STAFF RECOMMENDATION
423 Broadway
August 16, 2017

Application: New construction, Illumination, and Signage-violations

District: Broadway Historic Preservation Zoning Overlay

Rooftop area 423 Broadway

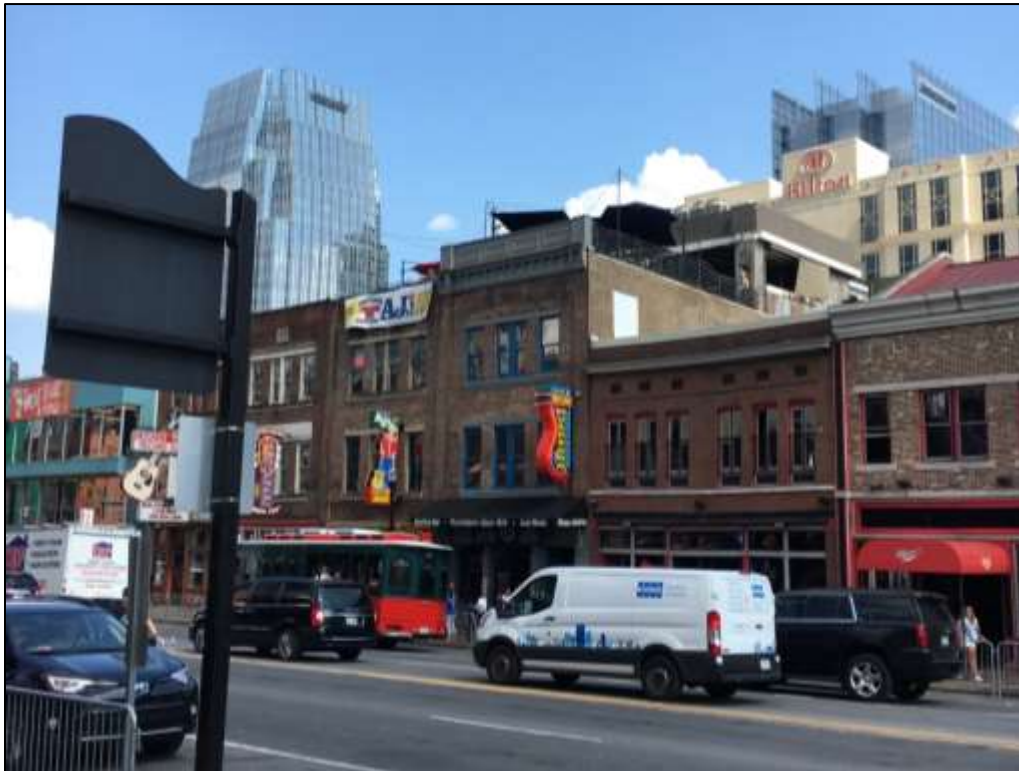
Violations – New Construction, Illumination: The rooftop addition was initially constructed as approved, with its front wall set back more than thirty feet (30’) from the front wall of the building, in accordance with the district design guidelines. Recently the business installed poles for string lighting. (See figures 1 -3.) New construction should step back from the front wall at least thirty feet (30’) to ensure that new construction is not “visually jarring or contrasting” and that it is “minimal” compared to the historic building. Permanently-installed features forward of the thirty foot (30’) set back do not meet the design guidelines. The project does not meet section H of the design guidelines for additions.

Lighting was also added to the rooftop. (See figure 2.) The design guidelines call for lighting to be “simple and unobtrusive in design, materials and relationship to other façade or elevation elements.” String lighting and the requisite poles needed for installation of the lighting is not appropriate in the stepback area as it is highly visible and the addition should be subordinate to the historic building. (In addition, the lighting may not meet code section 17.28.100 which does not allow for “excessive rope lighting,” which includes “strand lighting, lite ropes, flexible impact lighting, tubular lighting, string lighting, or other similar forms of illumination.”)

Staff recommends non-permanently installed lighting such as electric table candles or bollard lighting that does not extend above the parapet. The project does not meet section II.T for lighting.

Recommendation: Staff recommends disapproval of the installed rooftop features and unpermitted signage, recommending that they be removed within 30 days, finding the project does not meet Section III.H for Additions, Section II.T for Lighting, and Section IV for Signage.
